APPENDIX A

A2. Correspondence

- i. 1st Submission Comments***
- ii. Meeting Minutes***
- iii. Hydrologic Modelling***
- iv. Buffers and Allowances***

**DRAFT PLAN OF SUBDIVISION
ORLANDO CORPORATION**

Project No.	99067A
Date	MARCH 2000
Scale	1:20,000
Figure No.	4

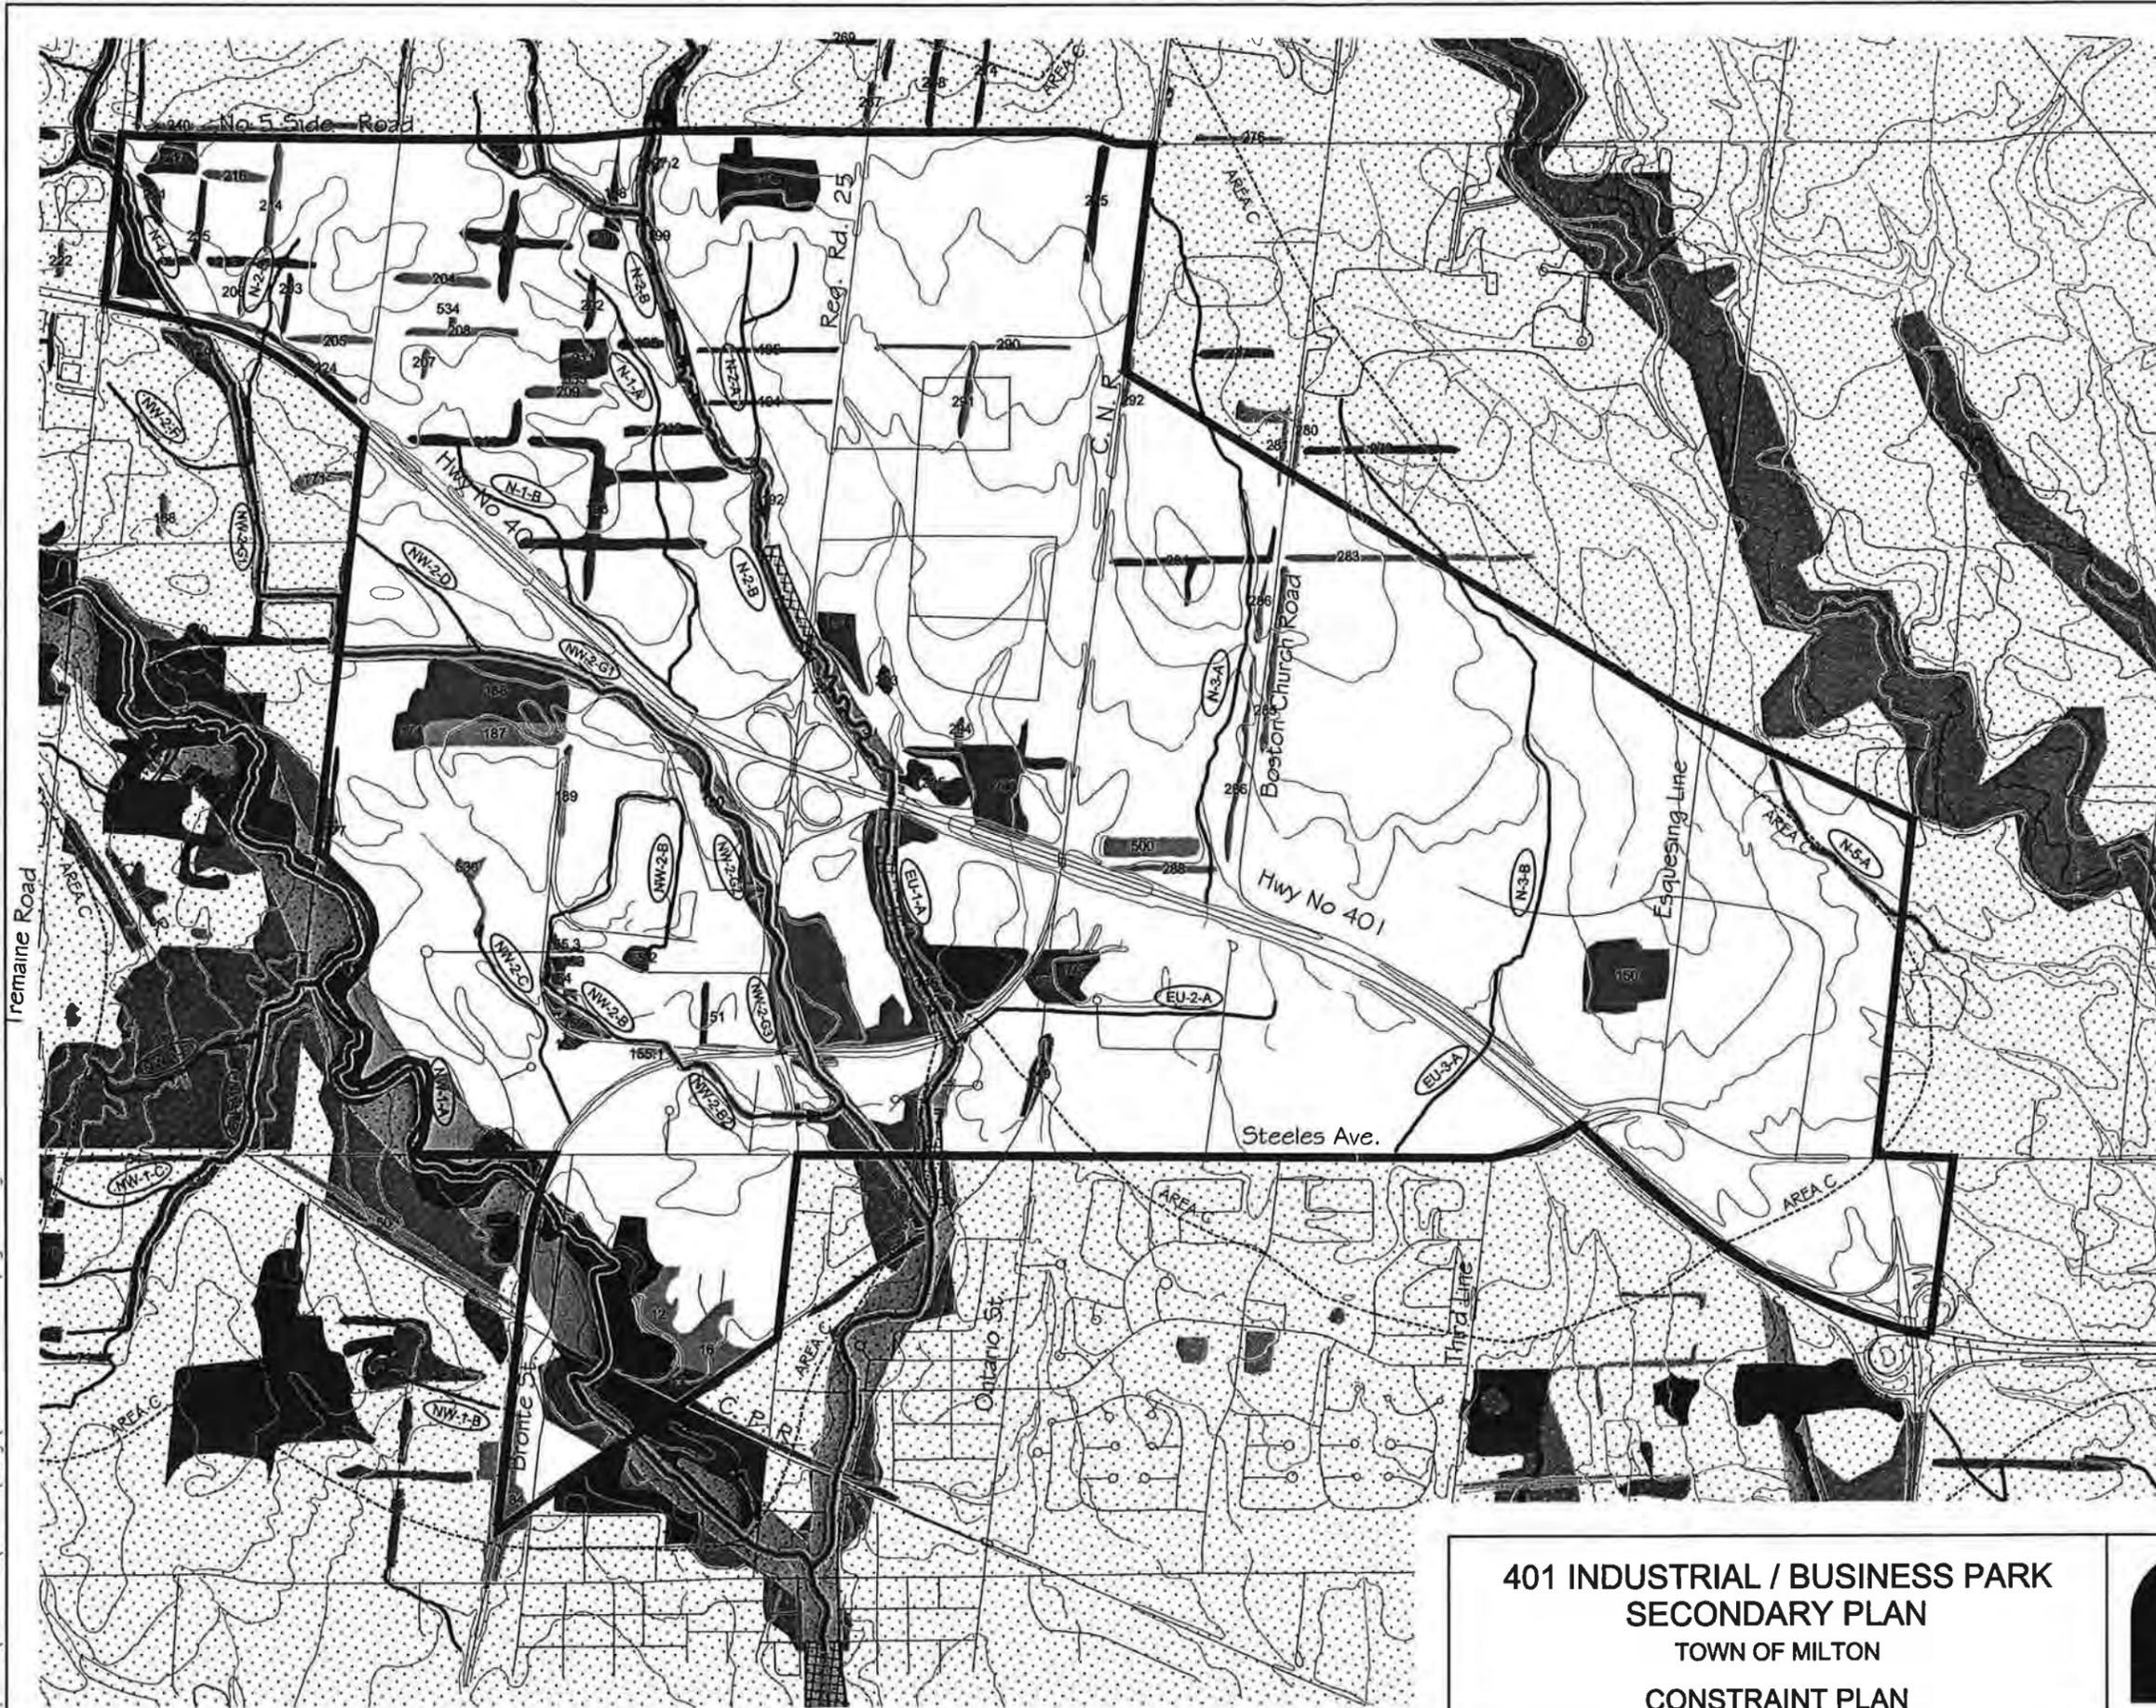
- Figure 4 - Kelso branch should be identified as a high fisheries constraint. Tributaries N-5-A (Mansewood) and NW-2-B2 should be identified as medium fisheries constraints.

- Table 3.7 - Summary of Watercourse Functional Characteristics requires the following revisions:
 1. Based on Figure 4, NW-1-E should be listed as "Red";

2. Based on Figure 4, NW-2-B is both "Blue" and "Green";
 3. NW-2-E, NW-3-A, NW-3-C and N-2-C are not shown on Figure 4;
 4. N-2-E and all EU watercourses are missing from Table 3.7.

✓ Figure 4, Constraint Plan, within the Legend, the two symbols for fisheries – high constraint and fisheries-medium constraint are the same.

Project No.	99067A
Date	MARCH 2000
Scale	1:20,000
Figure No.	5

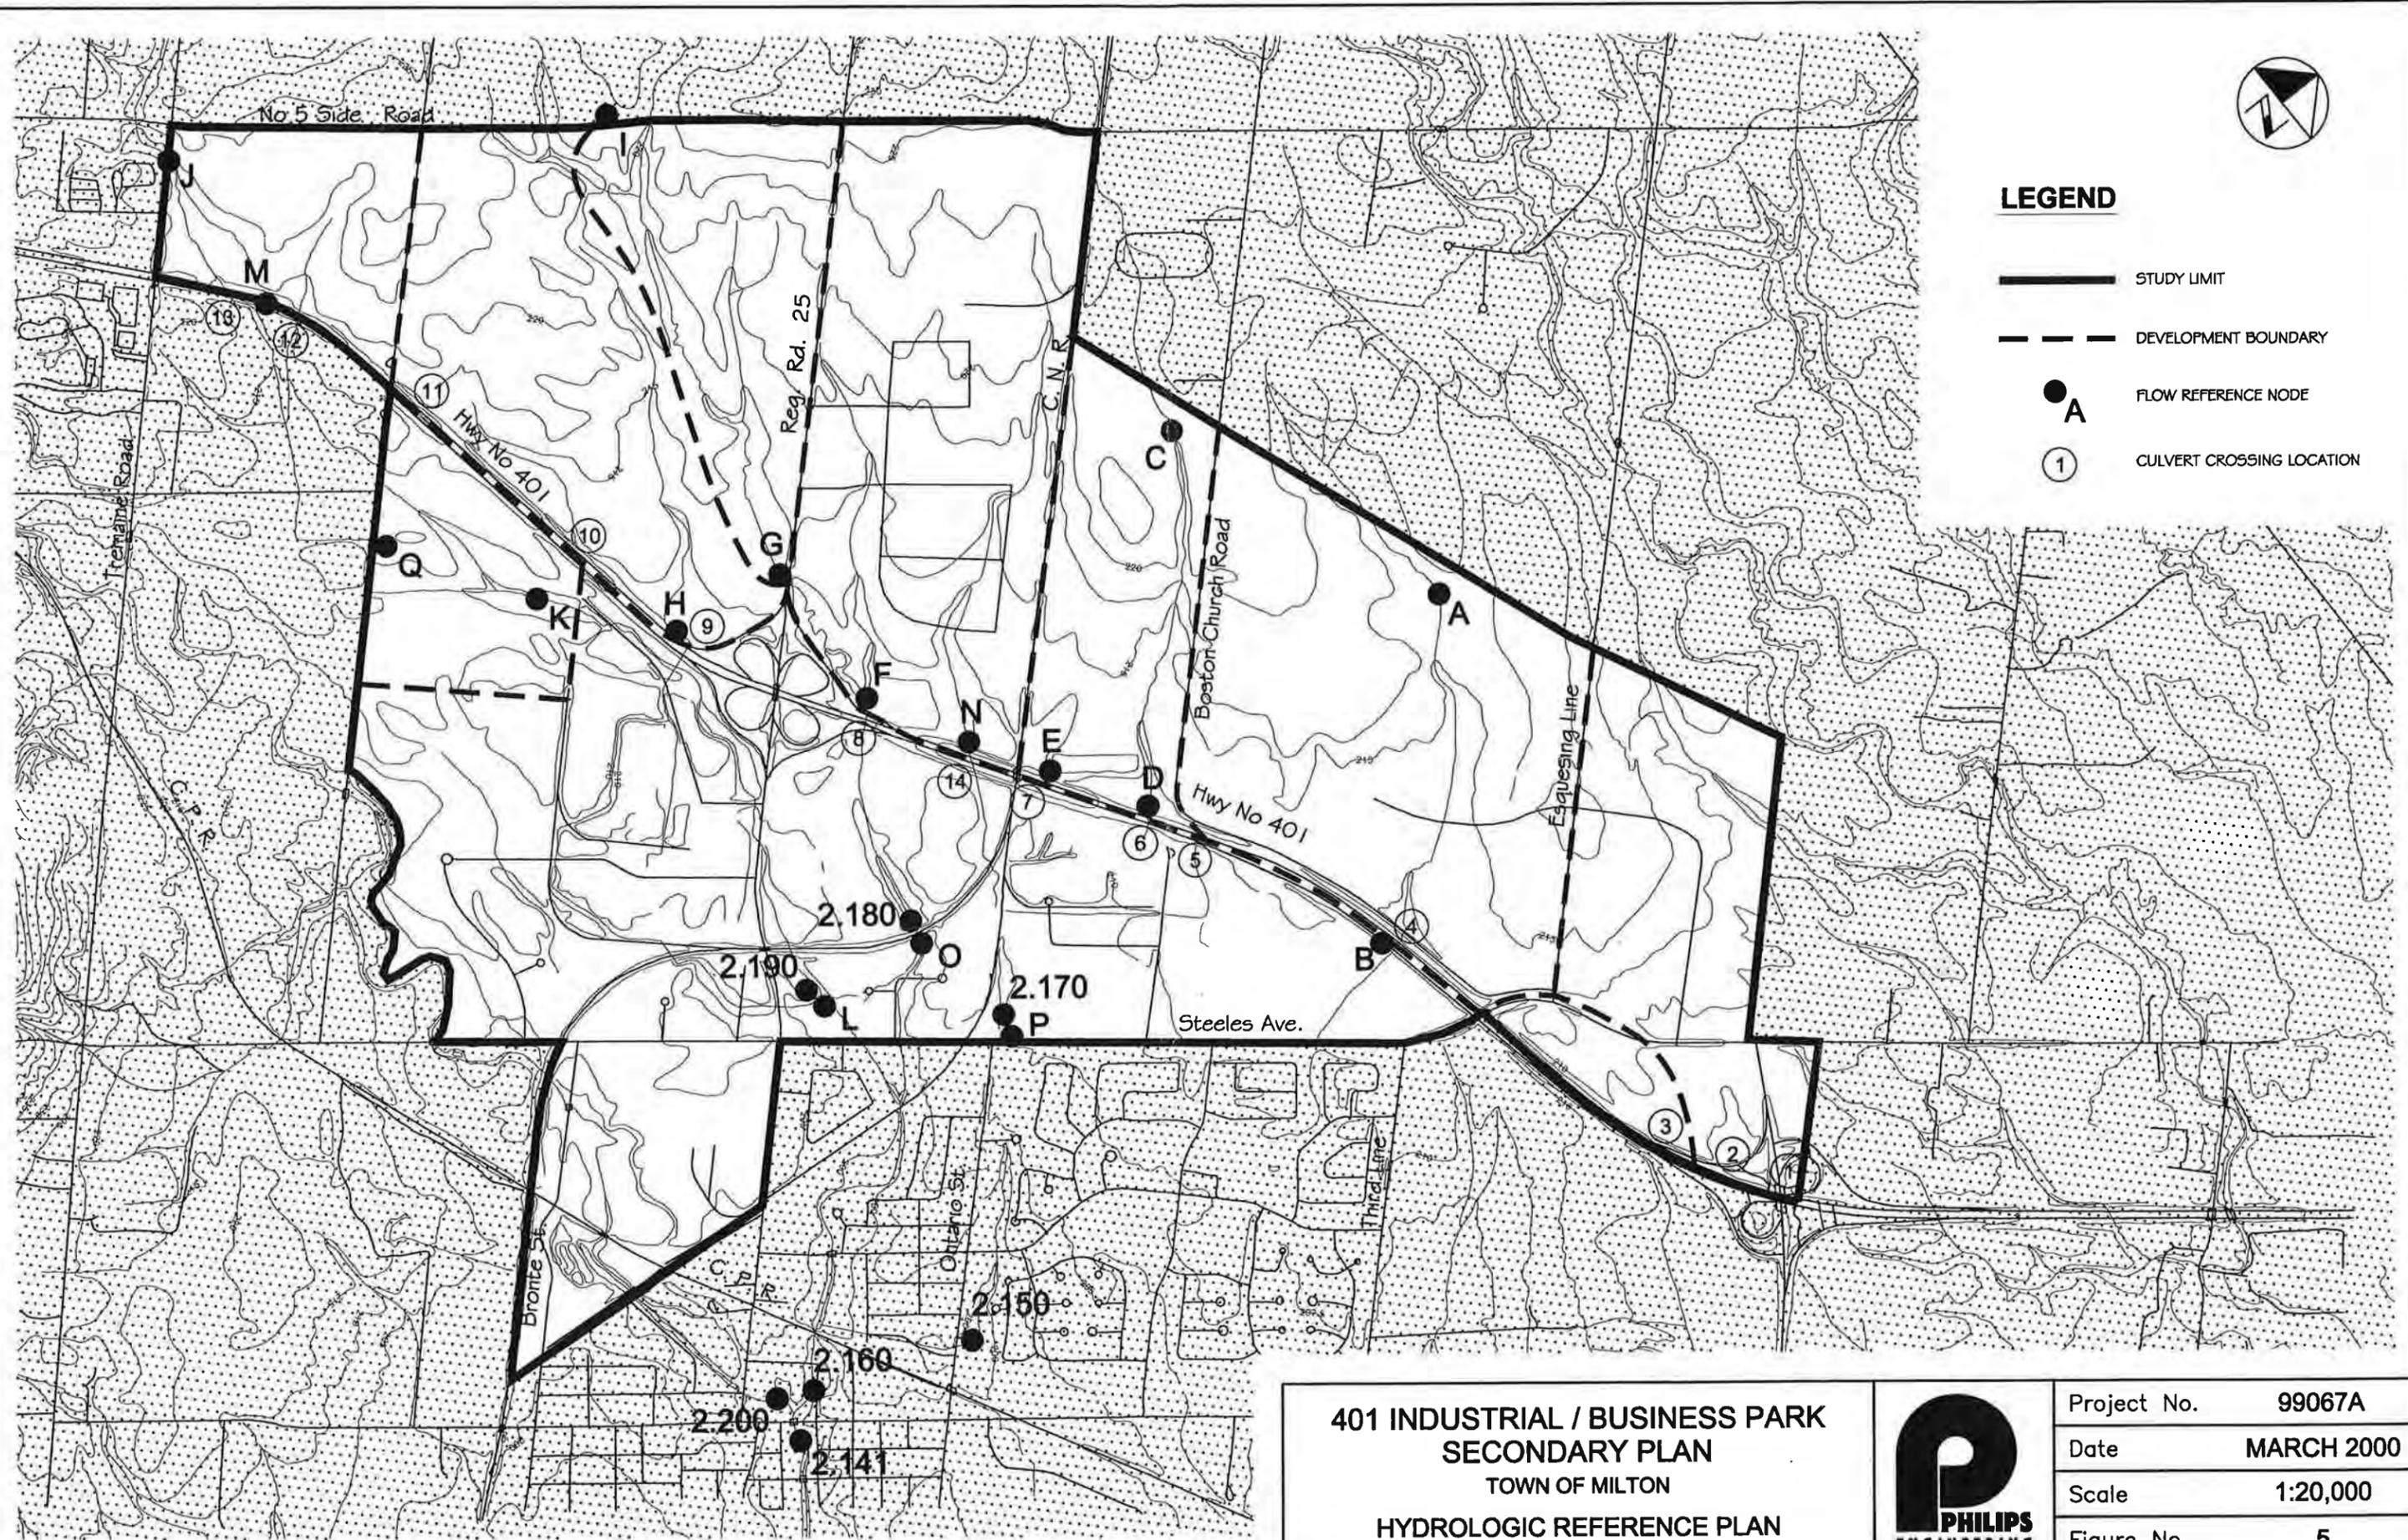
Figure 5 - Sizes assumed by Philips should be included on the drawing (i.e. all 300 mm except 3-1B/C and 4-1, which are 500 mm). A footnote summarizing the assumptions noted in the last paragraph on Page 17 should be provided on the drawing. The Region will summarize what constitutes a development charges main once sizes have been established and confirmed. Philips should therefore delete the 'Future Watermain - HUSP' item from the legend (i.e. all future watermains should be identified using one colour - preferably blue for water).

Additional comments on Figure 5 include:

Project No.	99067A
Date	MARCH 2000
Scale	1:20,000
Figure No.	8

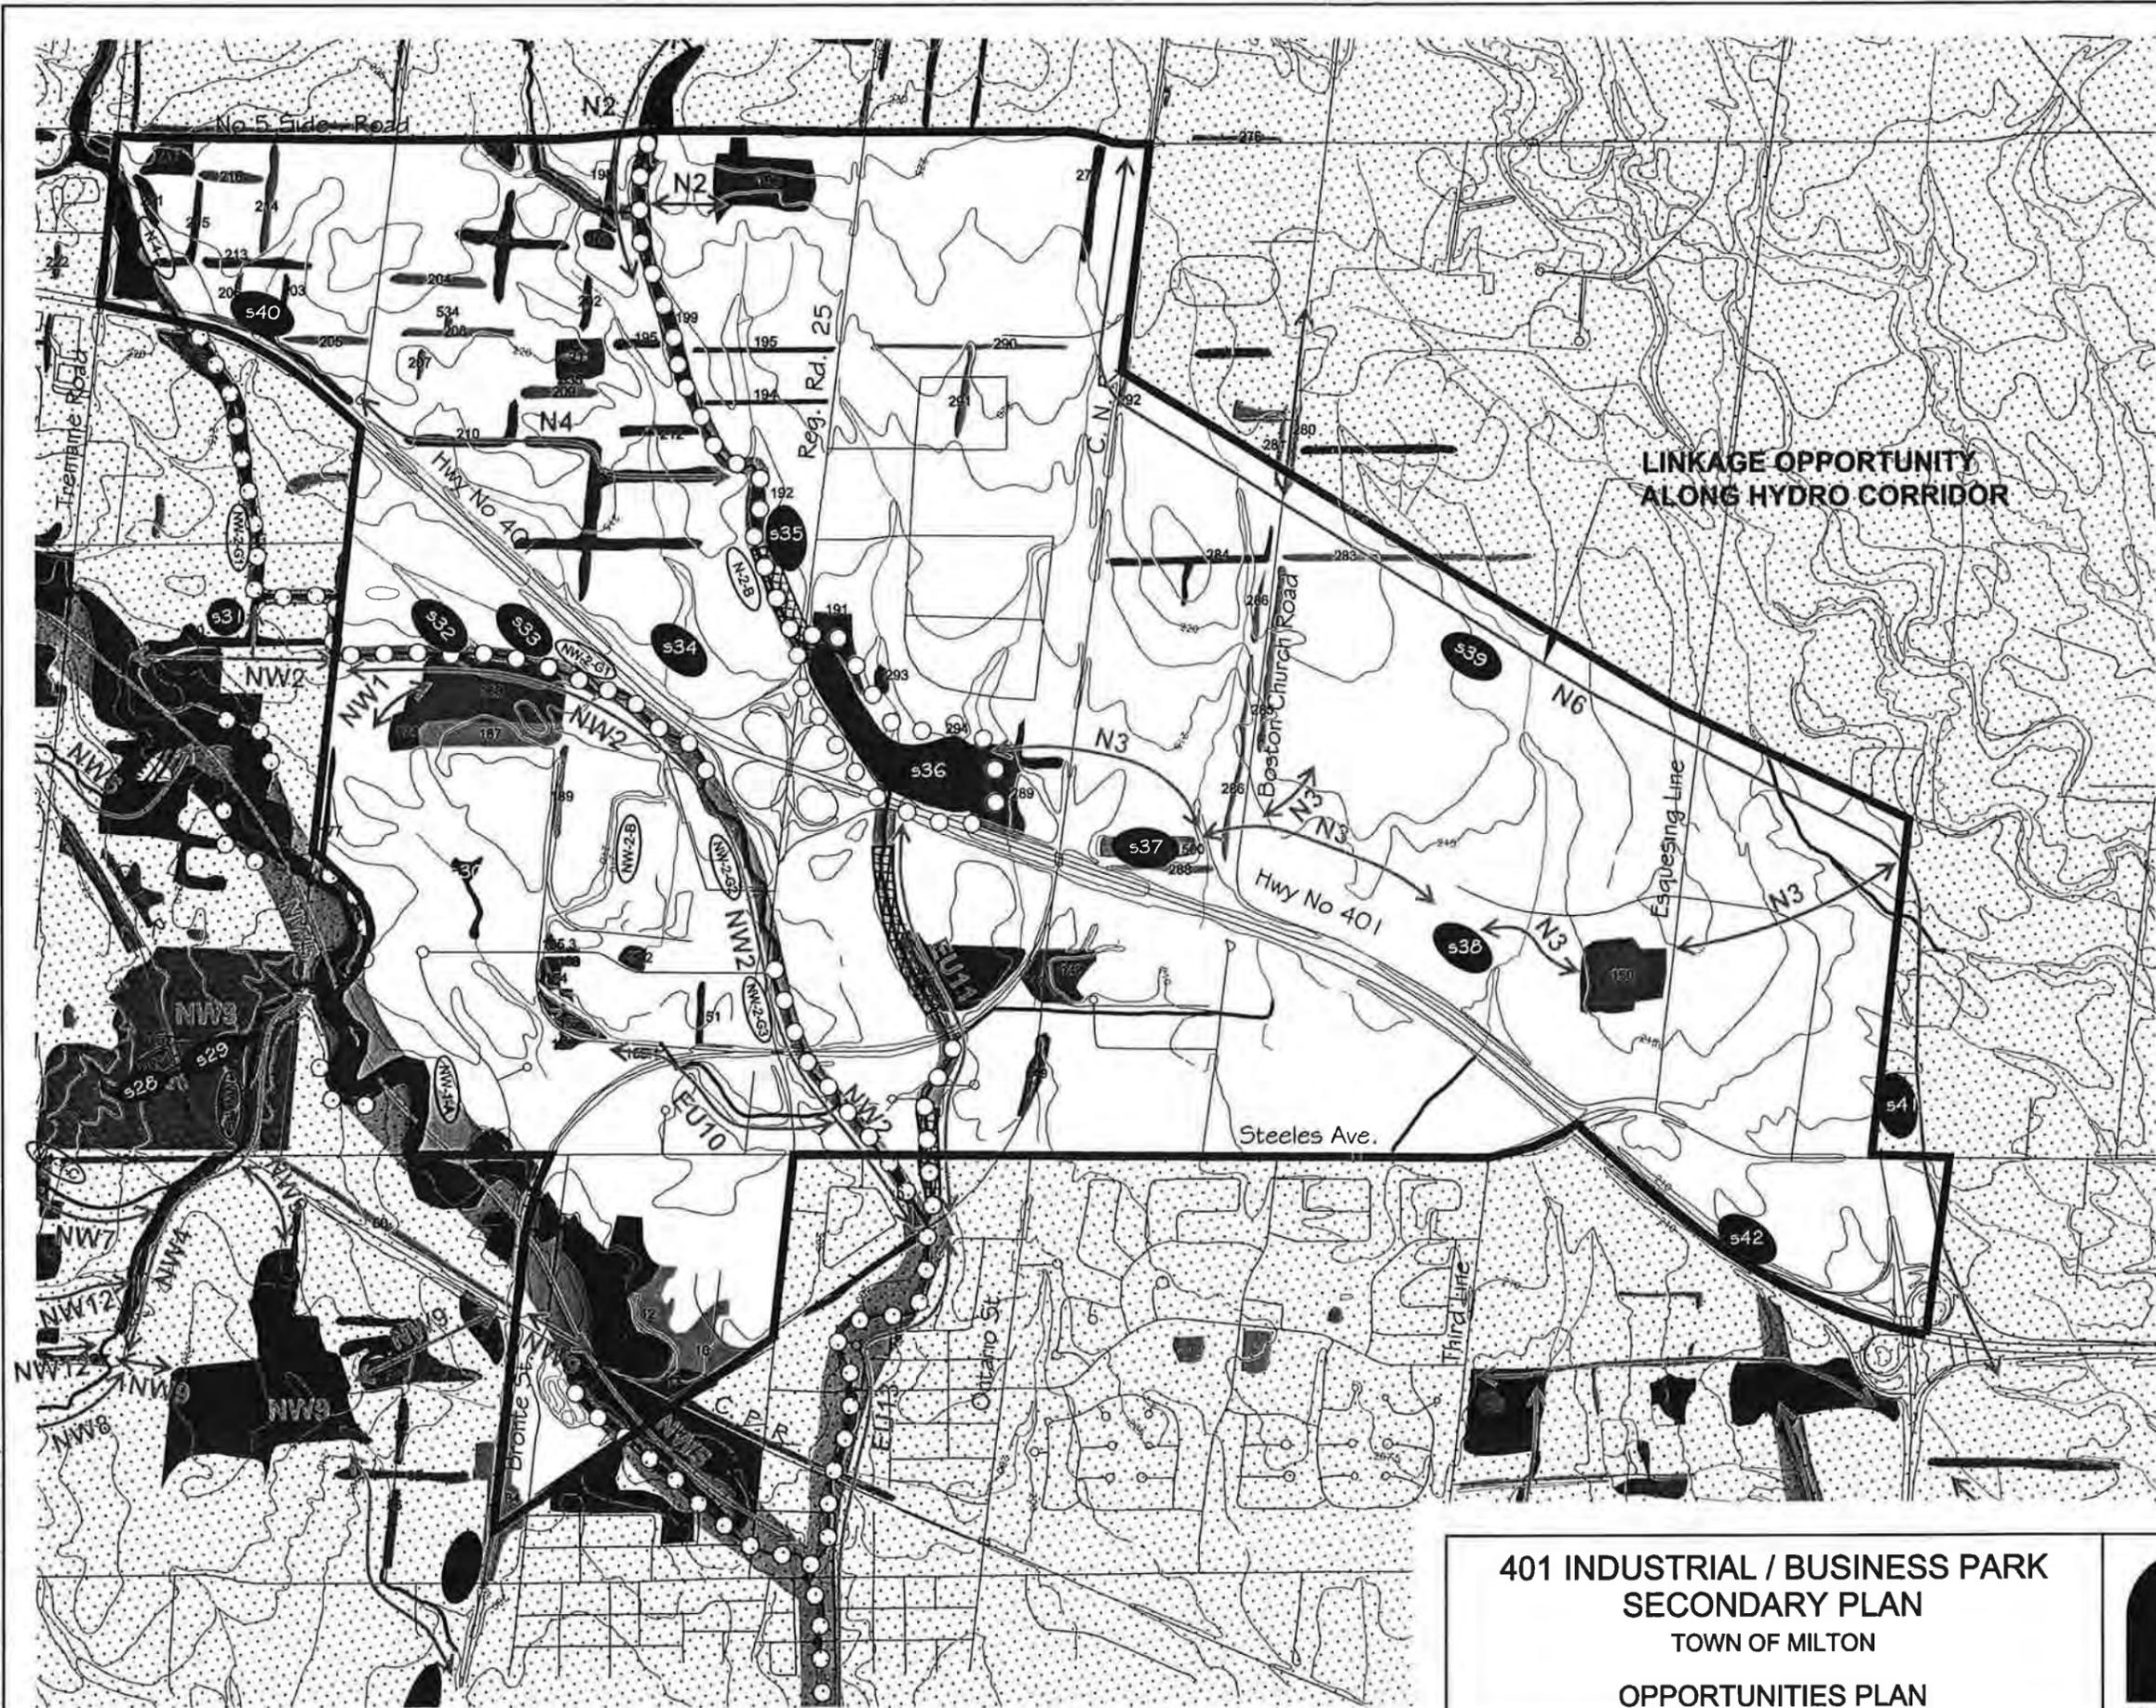
✓ Figure 8, Opportunities Plan, staff question why some of the terrestrial units are not numbered.
